SUBJECT: RFP NO. 071755 ADMINISTRATION BUILDING ELECTRIC VEHICLE CHARGING STATIONS

**Response to Bid
Questions #03-R1**

ADMIN. BUILDING EV CHARGING STATIONS
DISTRIBUTION SERVICE DETAIL

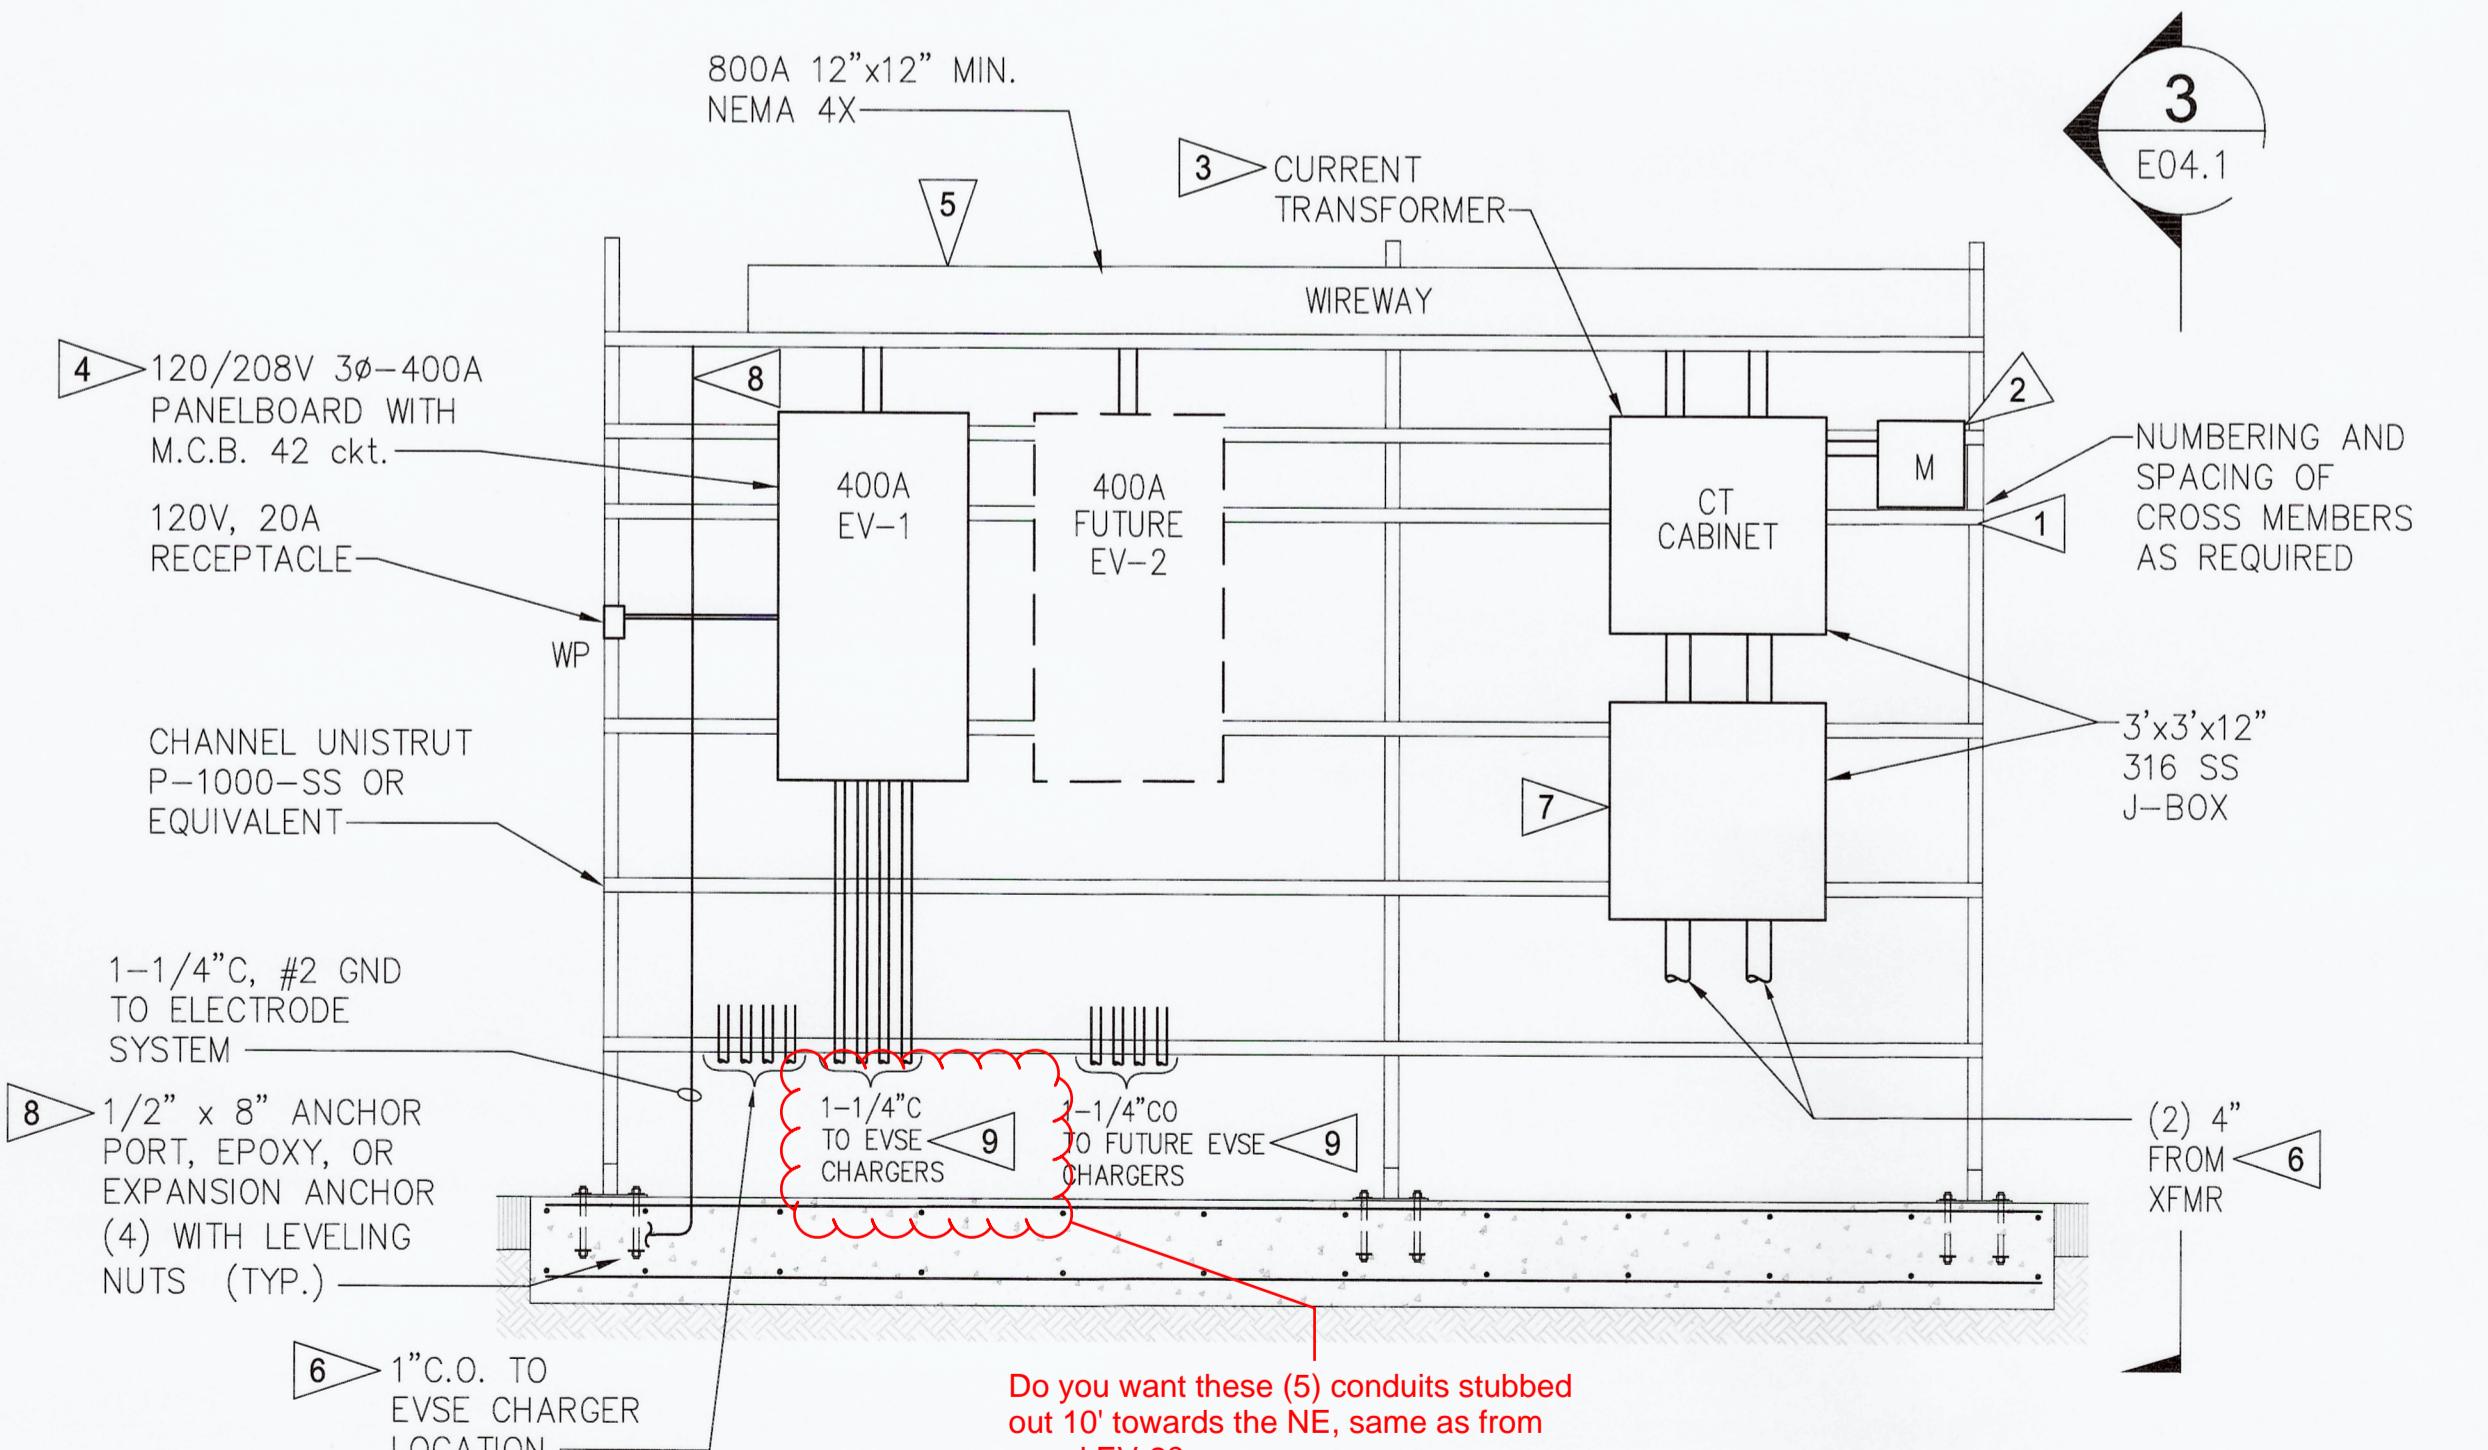
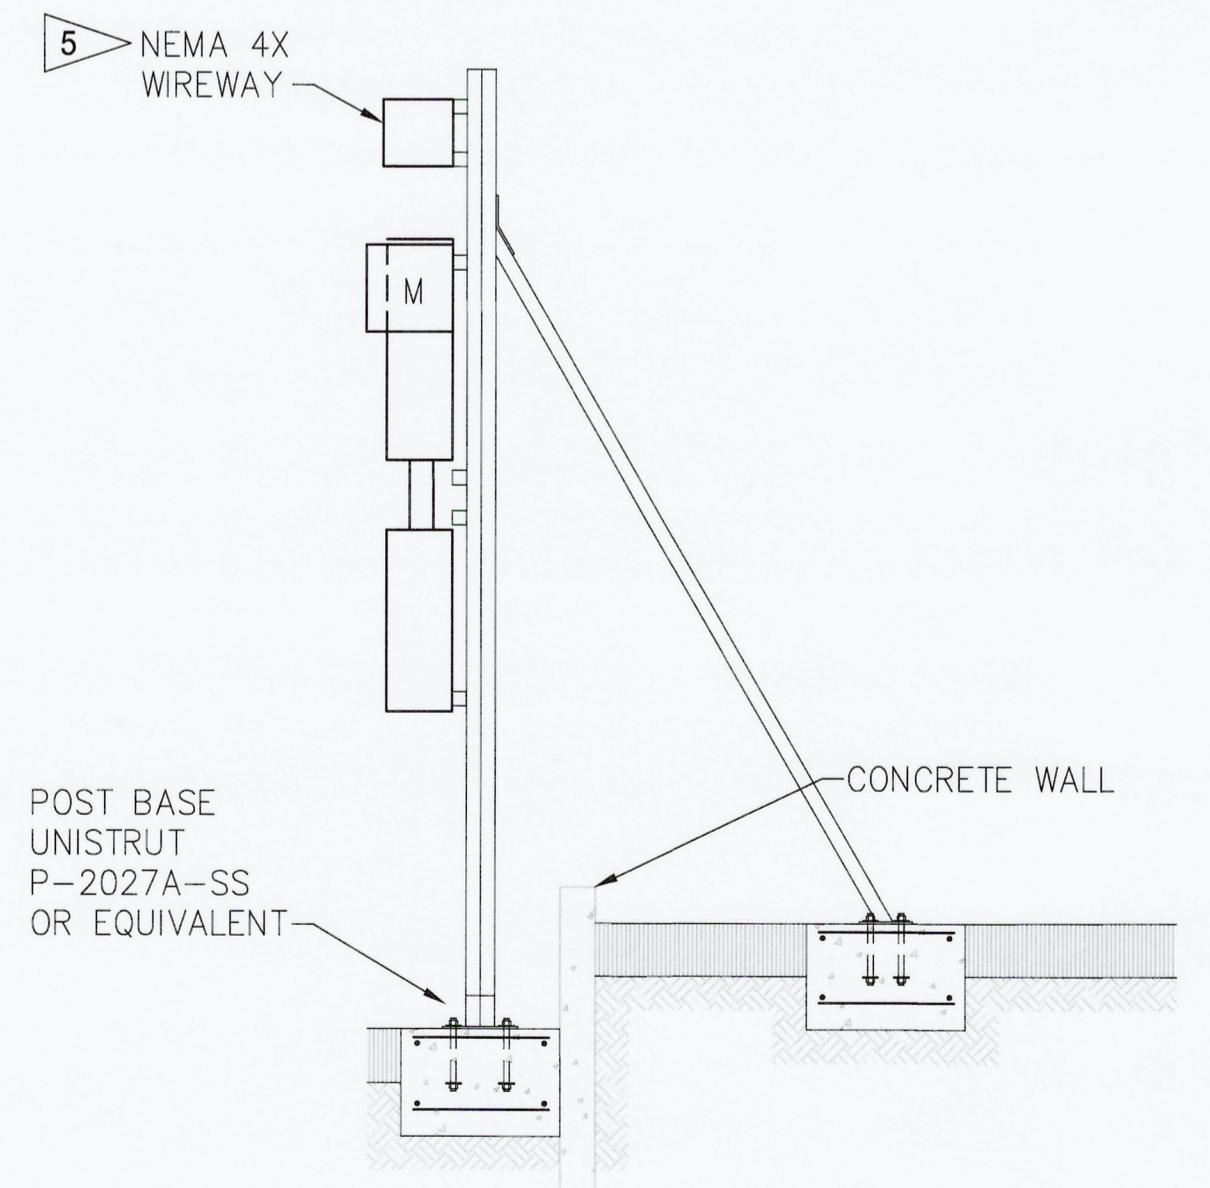
Flag note 6 indicates conduit and wire but, there is no information on what wire is needed for communications.

Do you want these (5) conduits stubbed out 10' towards the NE, same as from panel EV-2?

Where conduit only (C.O.) is identified on drawings for power or communications conduits, NO wire is required for those conduits. See bubbled revision A1 drawing E04.1 in addendum 1.

No, these power conduits are to base bid EVSE charger locations. Note flag 9 is to be flag note 6. (5) power conduits (C.O.) only from EV-2 and (5) communications conduits only (C.O.) from localized Communication location on back side of the equipment rack shall be stubbed 10 feet out to the NE for future EVSE charger locations. See bubbled revision A1 drawing E04.1 in addendum 1.

1. (5) 1 "communications conduits (C.O.) are required along with the power conduit to the future EVSE charger. Provide power and communications C.O. to NE location as described on Sheet E04.1 See bubbled A1 revision and flag note 9 drawing E04.1 in addendum 1.
2. Ground electrode conduit and conductor did not terminate in Wireway (Gutter). This was corrected on the drawing with notes to clearly identify requirements for ground electrode routing on the drawing. See bubbled A1 revision and flag note 8 drawing E04.1 in addendum 1.

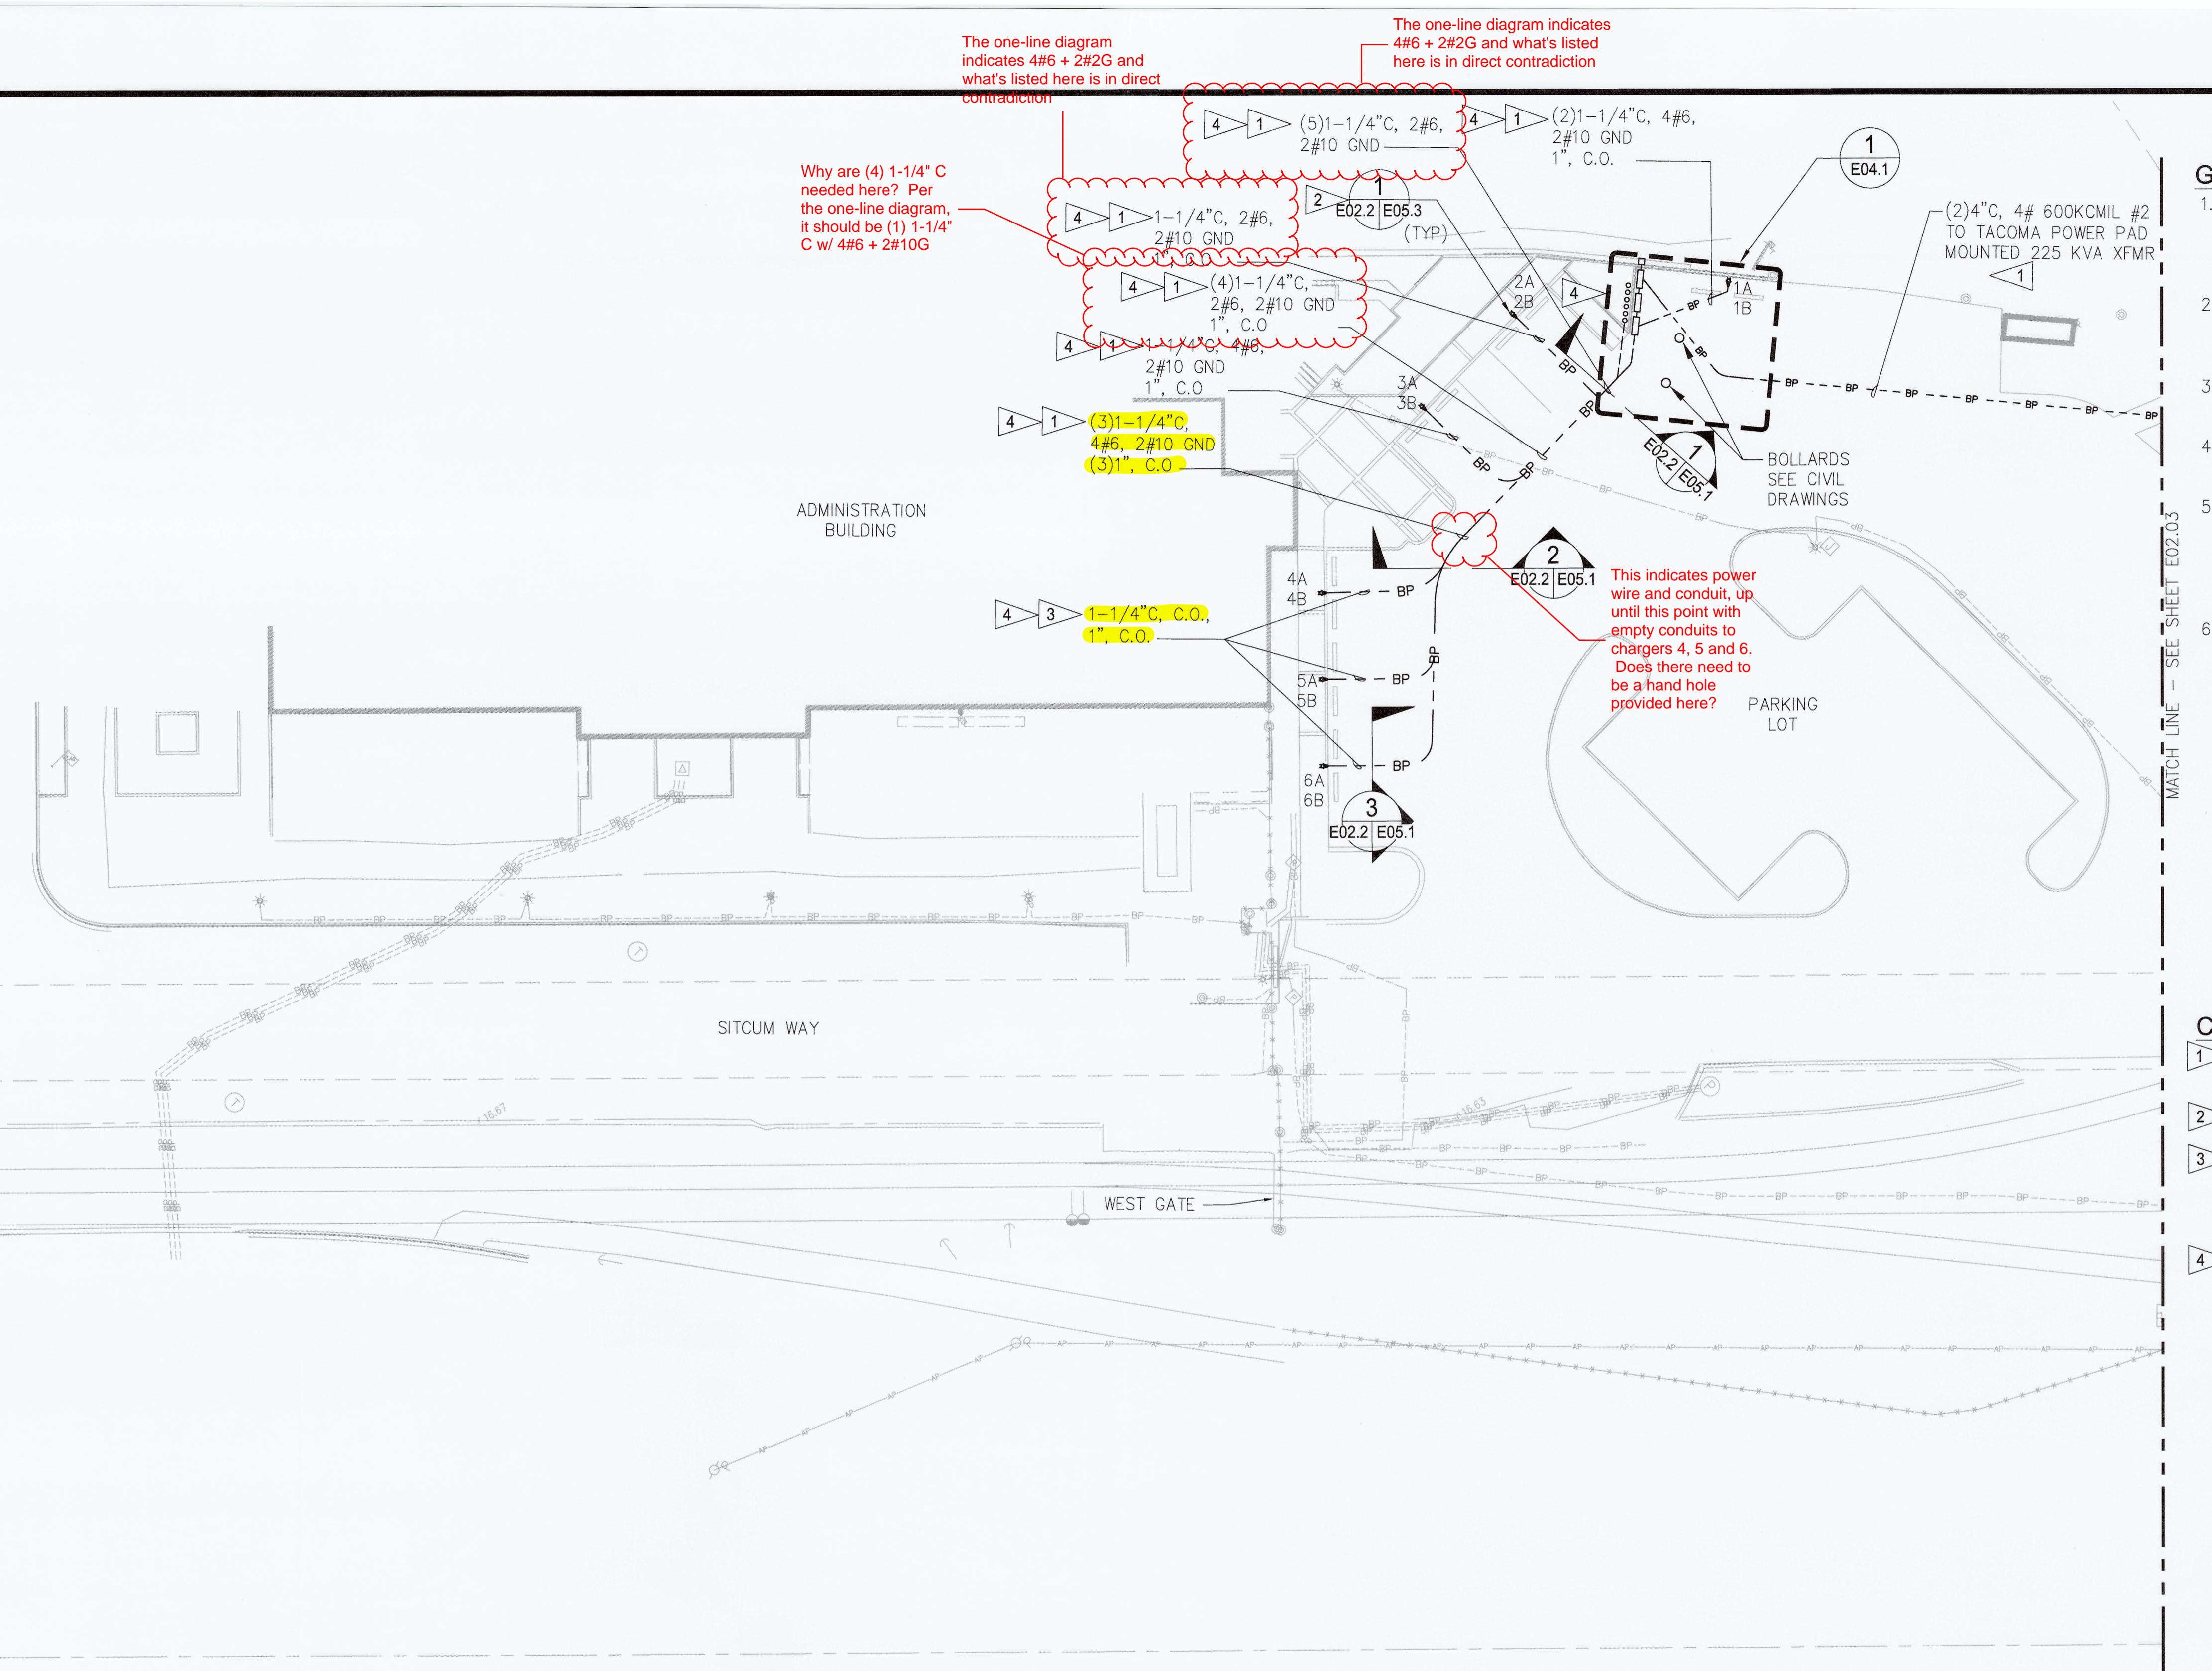
The one-line diagram indicates 4#6 + 2#2G and what's listed here is in direct contradiction.

Why are (4) 1-1/4" C needed here? Per the one-line diagram, it should be (1) 1-1/4" C w/ 4#6 + 2#10G.

This indicates power wire and conduit, up until this point with empty conduits to chargers 4, 5 and 6. Does there need to be a hand hole provided here?

The one-line diagram indicates 4#6 + 2#10G. One line diagram is correct wire count. Plan view conduit wire count has been adjusted to match one line diagram. See bubbled revision A1 drawing E02.2 in Addendum 1.

(4) 1-1/4" Power conduits are required at this point. (3) 1-1/4" power conduits shall be conduit only (C. O.) and one will be filled, (1) filled 1-1/4" C w/ 4#6 + 2#10G. Plan view

conduit and wire count has been adjusted to match one line diagram. See bubbled revision A1 drawing E02.2 in Addendum 1.

Conduit only is required for base bid from panel EV -1 to bid alternate EVSE locations. Conduit fill wire will be required only if bid alternate EVSE locations are accepted for work. NO wire transition will be required at this point.

Plan view conduit and wire count has been adjusted to match one line diagram. See bubbled revision A1 drawing E02.2 in Addendum 1.
